CHANGE ORDER

Project Name: **Haverhill Consentino Middle School** CO No.

Architect's Project No. **21-0818**

See attached list of 8 item(s) for a total of**\$55,398.36**

(978) 499-2999

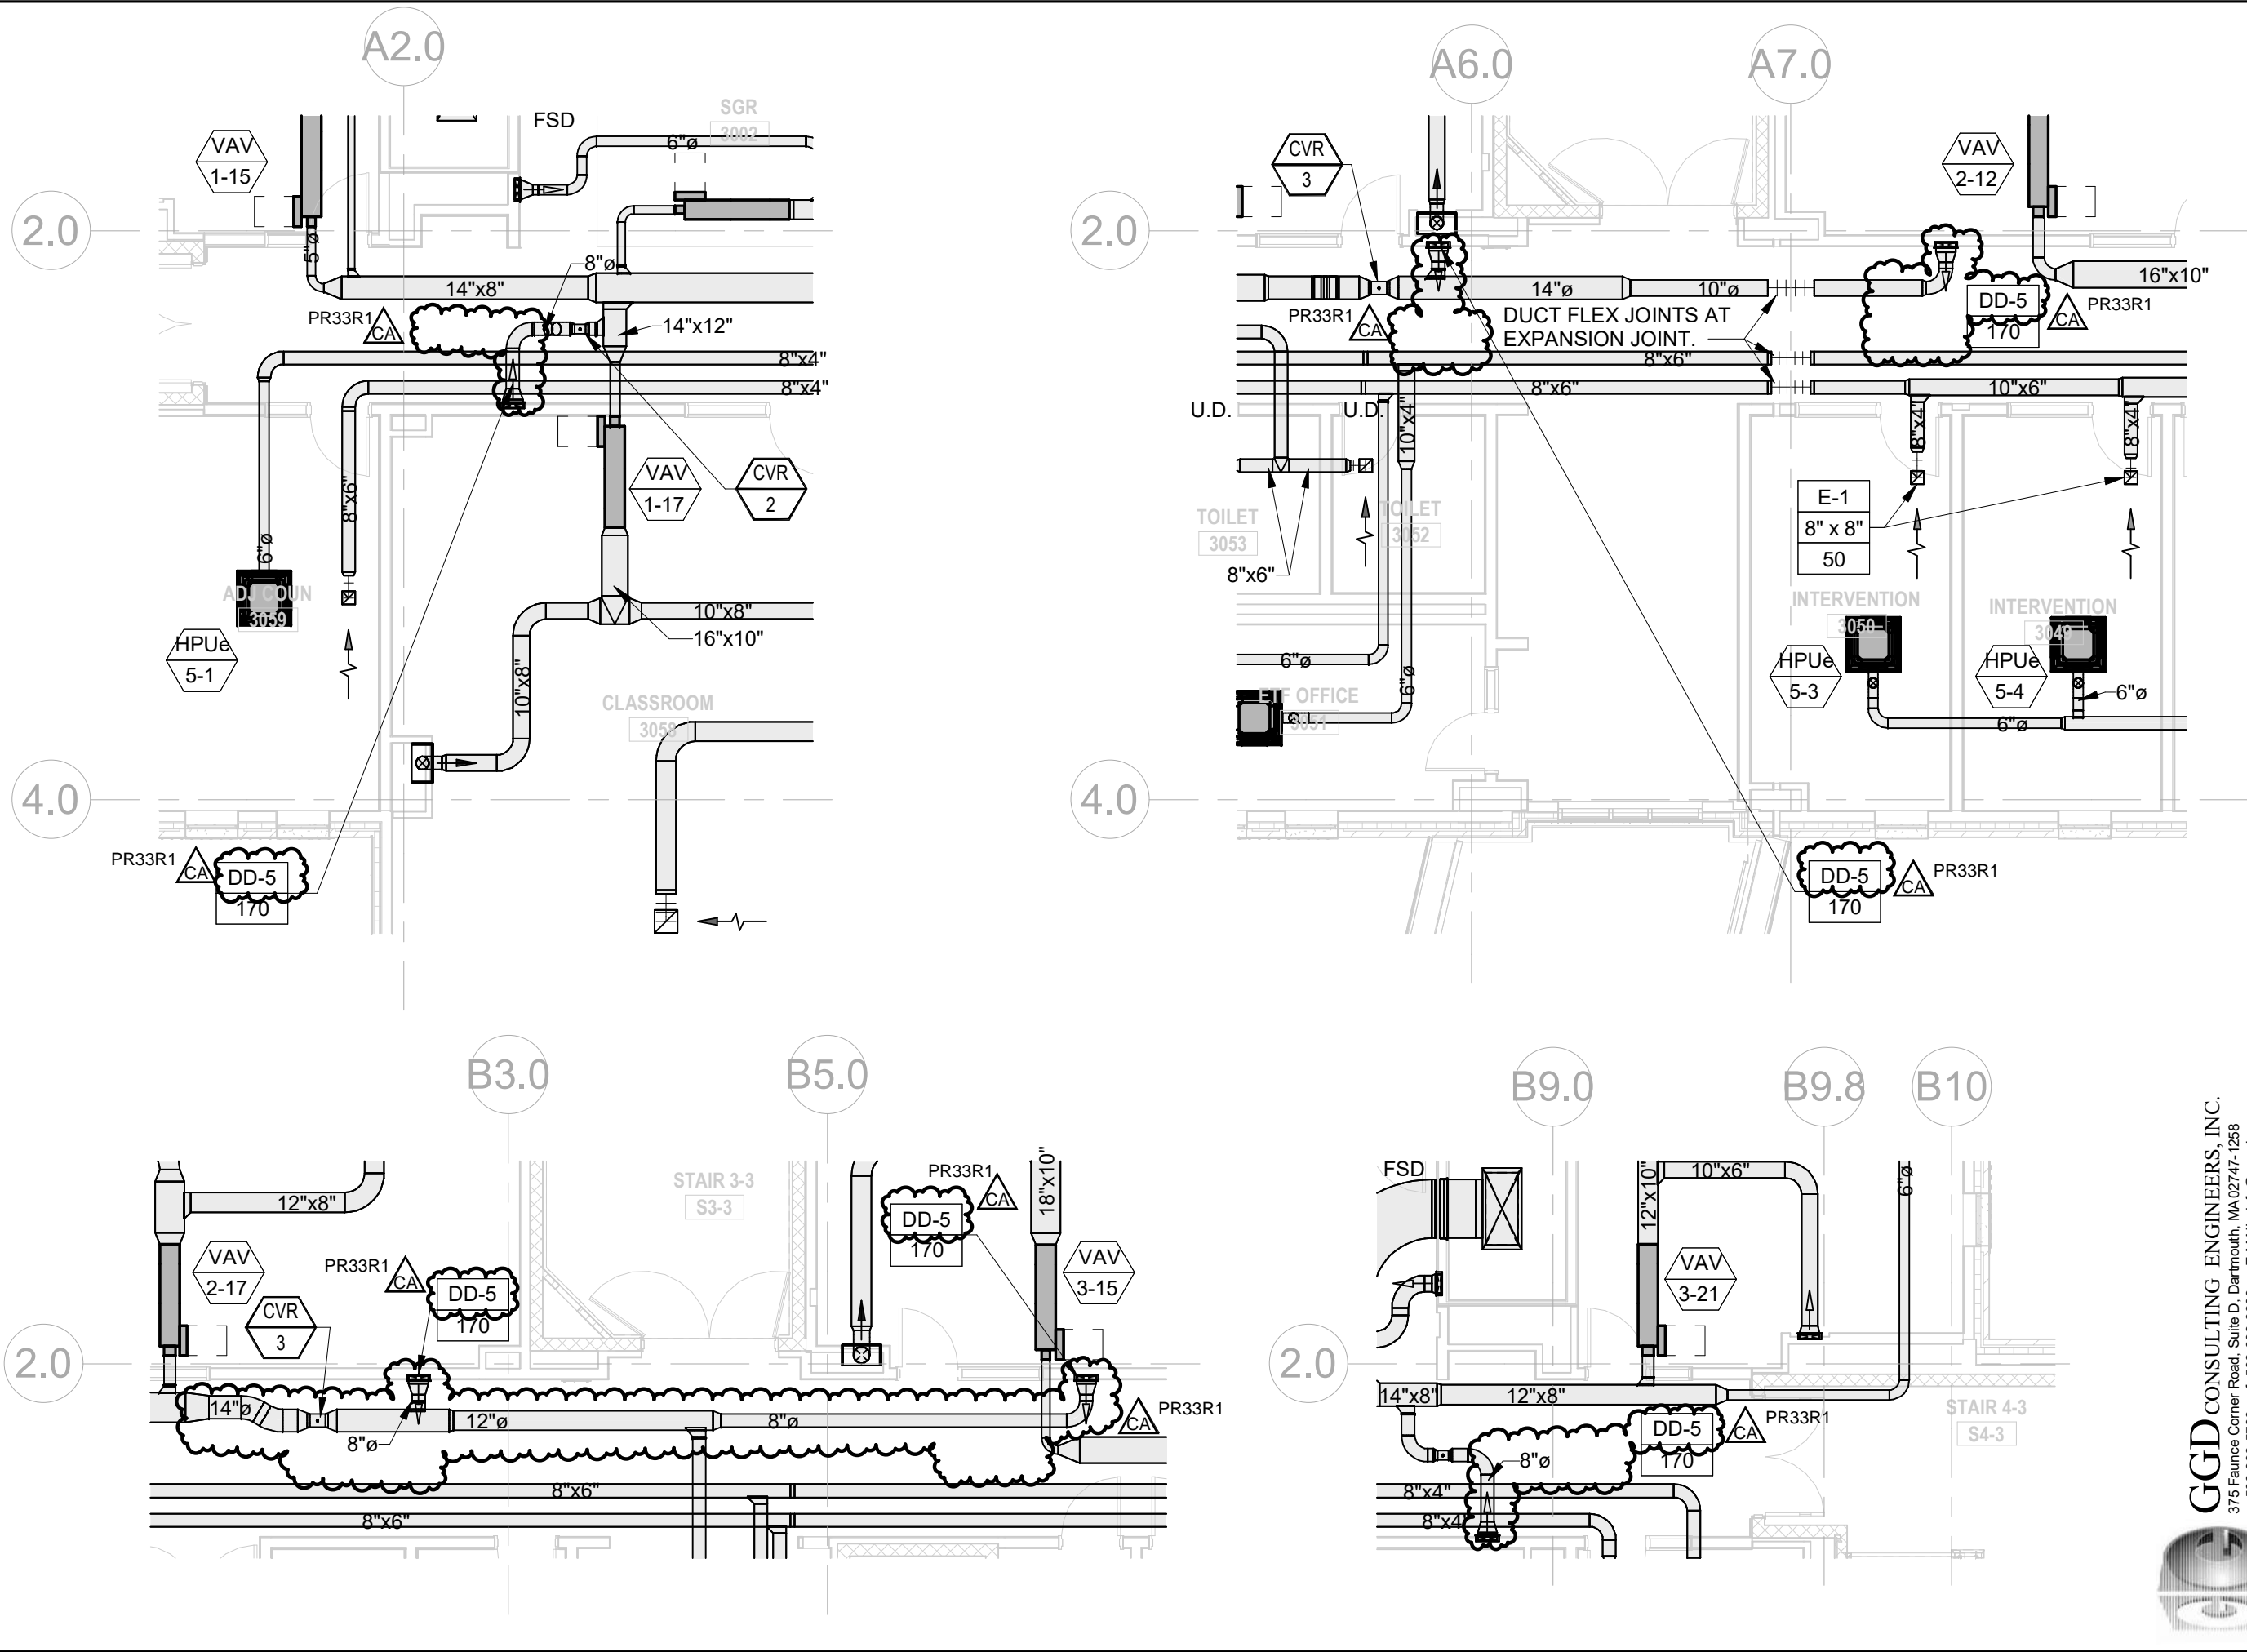
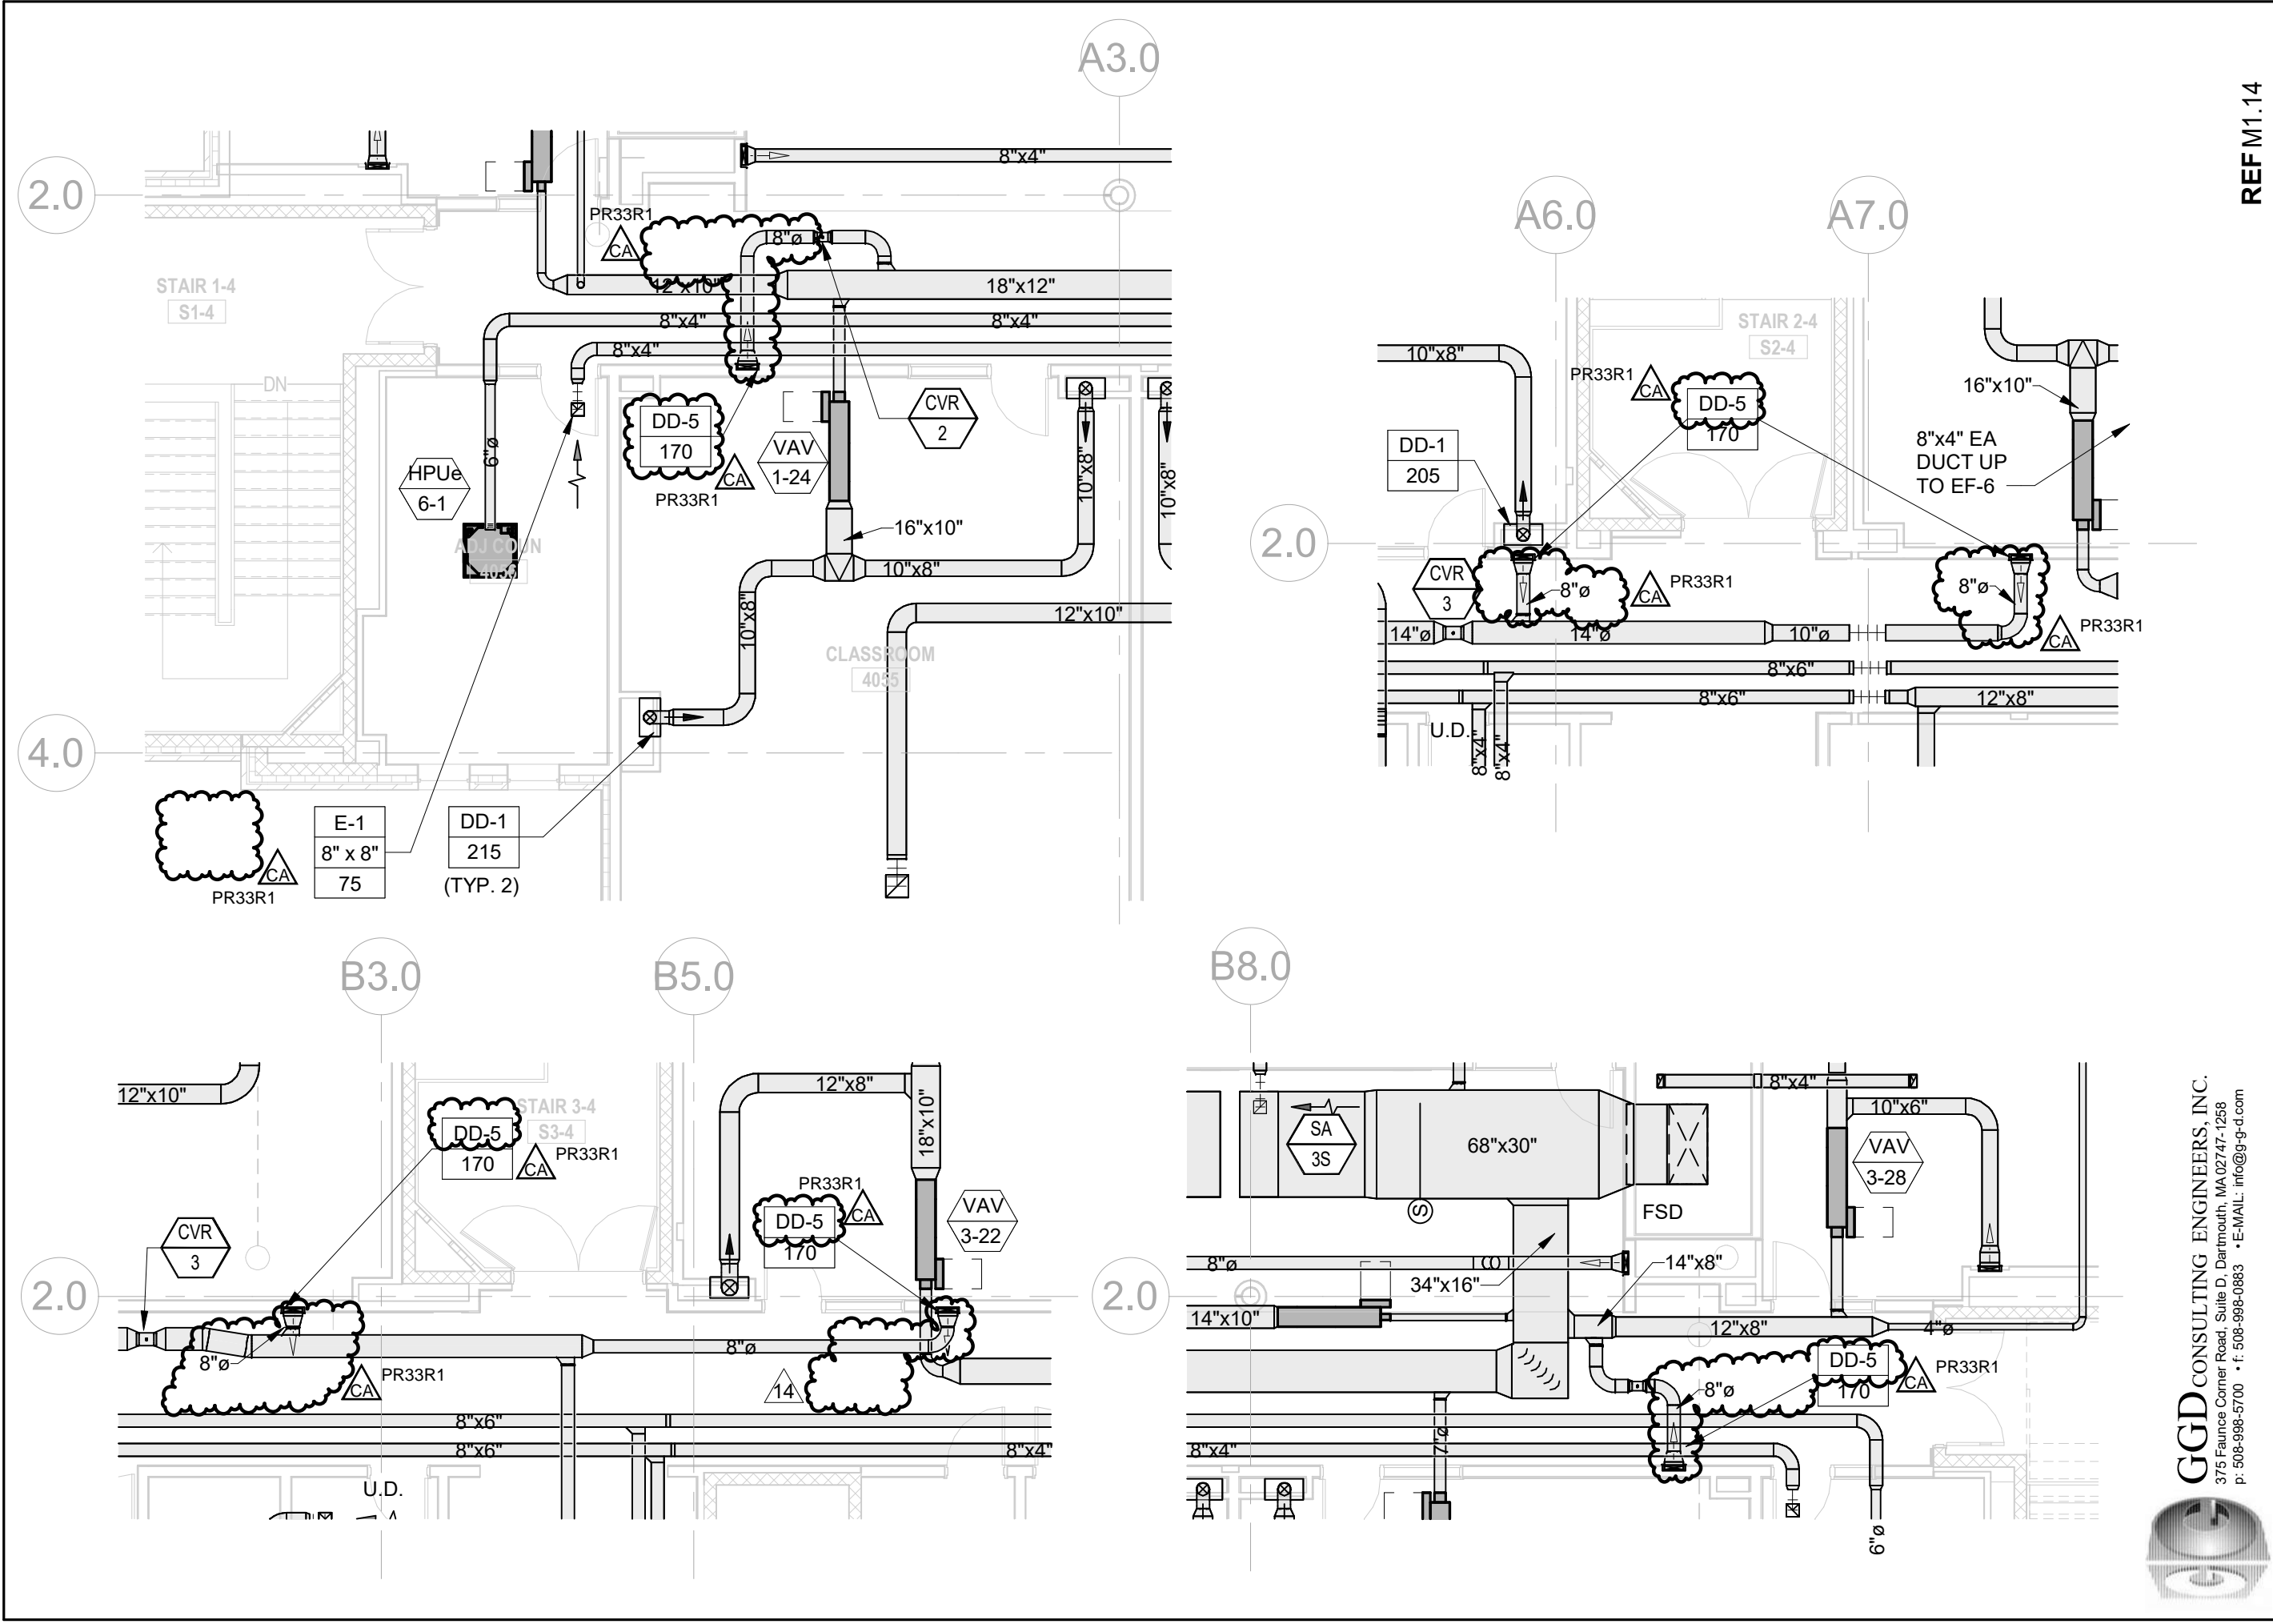
Refer to attached Equipment plans AQ1.11 and AQ1.31 for proposed wall mounted displacement cabinets in Area A/B Corridors. Make similar revisions to AQ1.21 and AQ1.41.

Per coordination call with Contractor and design team, Corridor ceiling displacement to be revised to wall mounted units. See attached sketches JD-76-JD-79 for proposed design changes to mechanical sheets M1.11, M1.21, M1.31, M1.41.
